SUNDRY NOTICES AND REPORTS ON WELLS
Do not use this form for proposals to drill or to re-enter an abandoned well. Use Form 3160-3 (APD) for such proposals.

EOG Resources Inc. (EOG) respectfully requests the execution of the variance for Wellhead break testing and offline cementing for the following wells, as outlined below (and with the additional Offline Cement Intermediate Operational Procedure):

**Revised Permit Information 08/16/2022:**

BATCH SUNDRY FOR BACKUP CASING DESIGN, OFFLINE CEMENTING AND BREAK TESTING. ALL PREVIOUS COAs STILL APPLY

Revised Wellbore A:

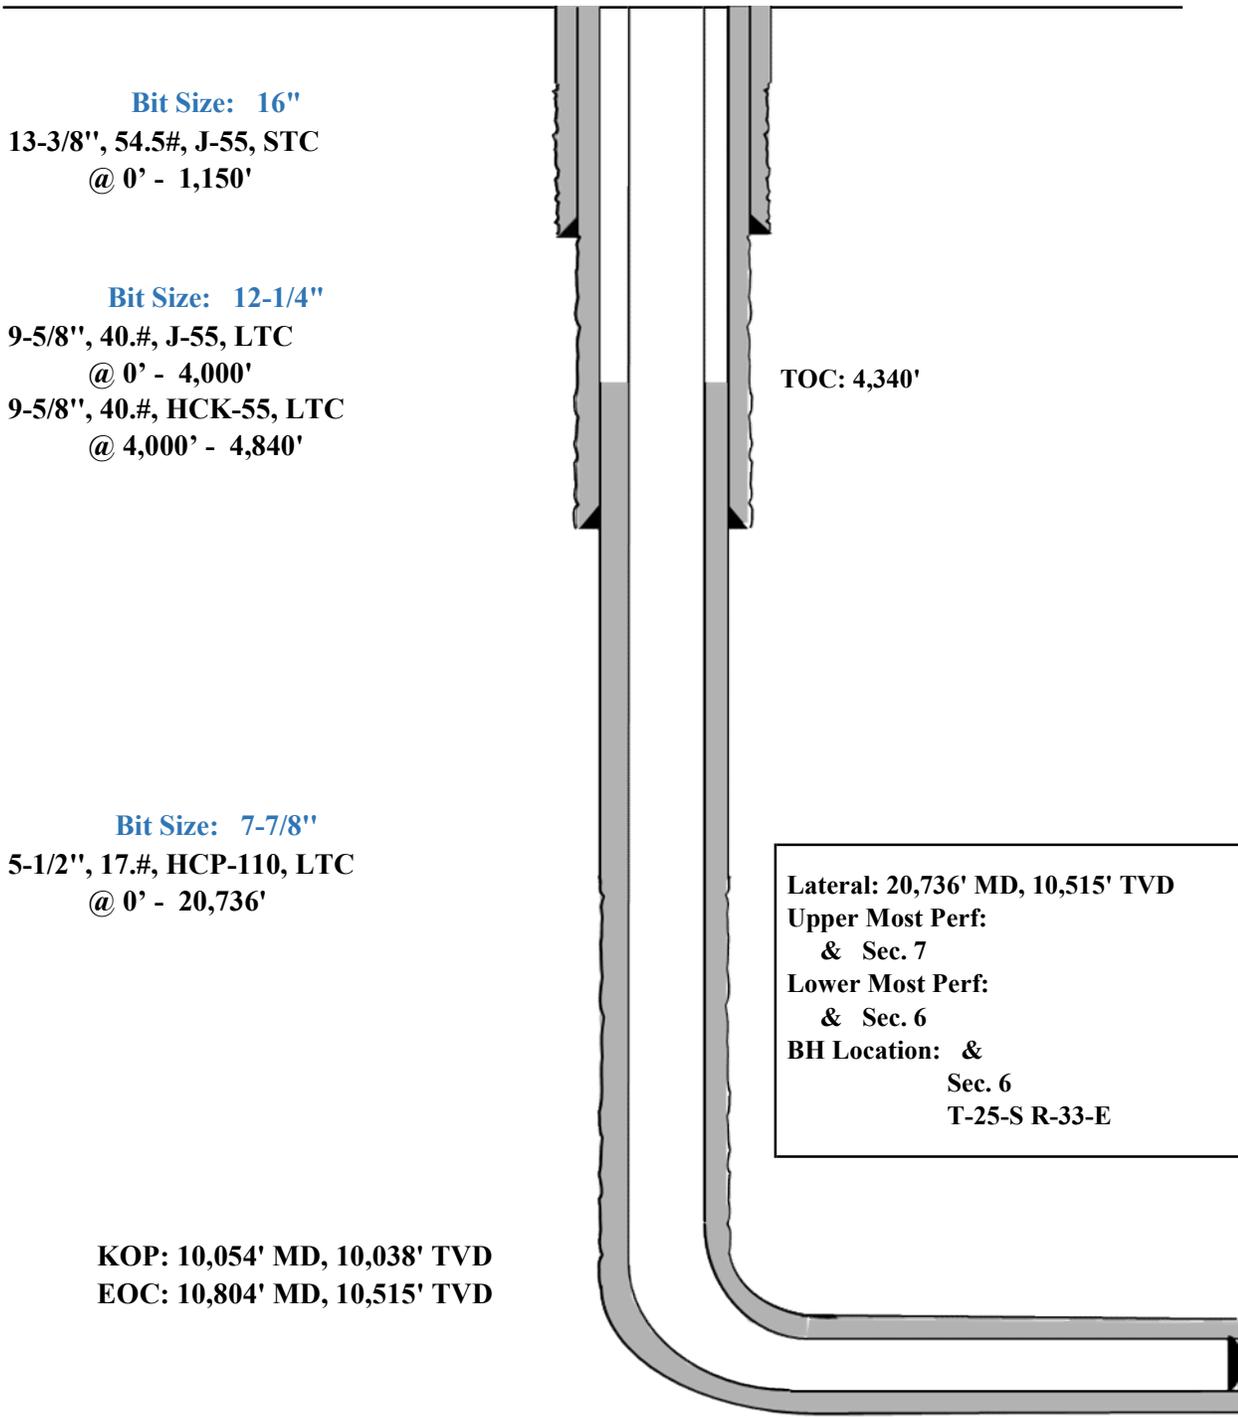
Casing Program A:

Variance is requested to waive the centralizer requirements for the 9-5/8" casing in the 12-1/4" hole size. An expansion additive will be utilized, in the cement slurry, for the entire length of the 12-1/4" hole interval to maximize cement bond and zonal isolation.

Variance is also requested to waive any centralizer requirements for the 5-1/2" casing in the 7-7/8" hole size. An expansion additive will be utilized, in the cement slurry, for the entire length of the 7-7/8" hole interval to maximize cement bond and zonal isolation.

Revised Wellbore B:

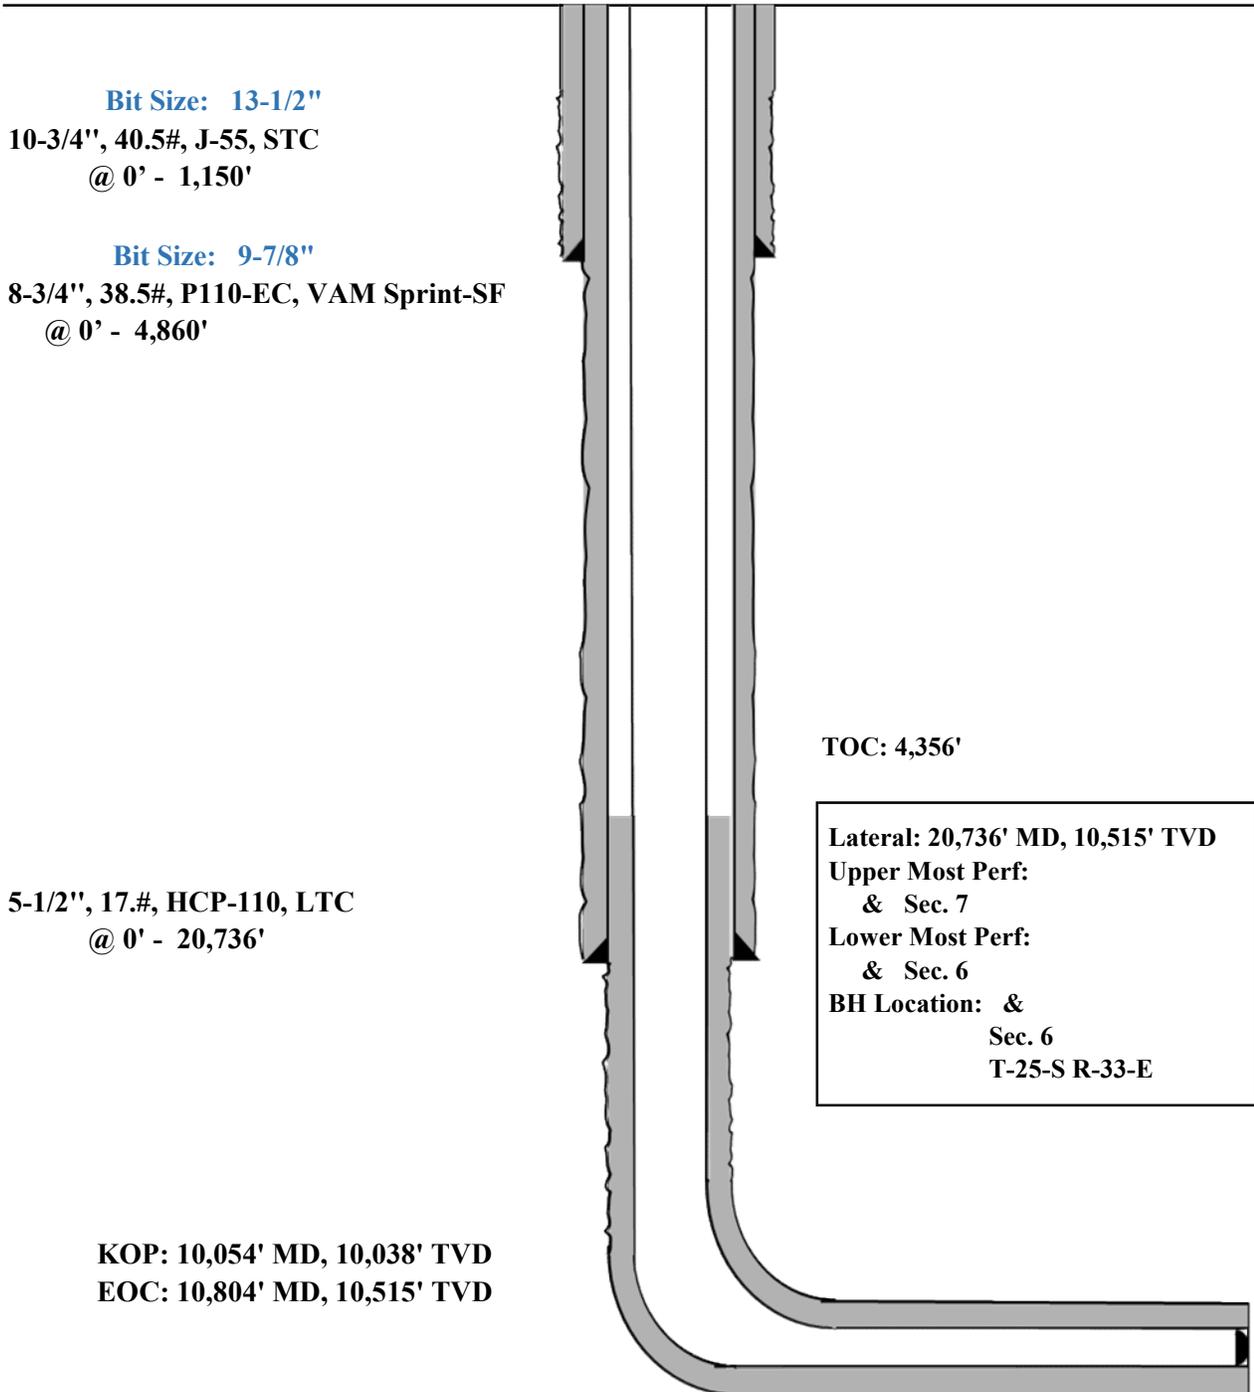
Casing Program B:

As a contingency, EOG requests to pump a two stage cement job on the 7-5/8" intermediate casing string with the first stage being pumped conventionally with the calculated top of cement at the Brushy Canyon (7,555') and the second stage performed as a bradenhead squeeze with planned cement from the Brushy Canyon to surface. If necessary, a top out consisting of 1,000 sacks of Class C cement + 3% Salt + 1% PreMag-M + 6% Bentonite Gel (2.30 yld, 12.91 ppg) will be executed.
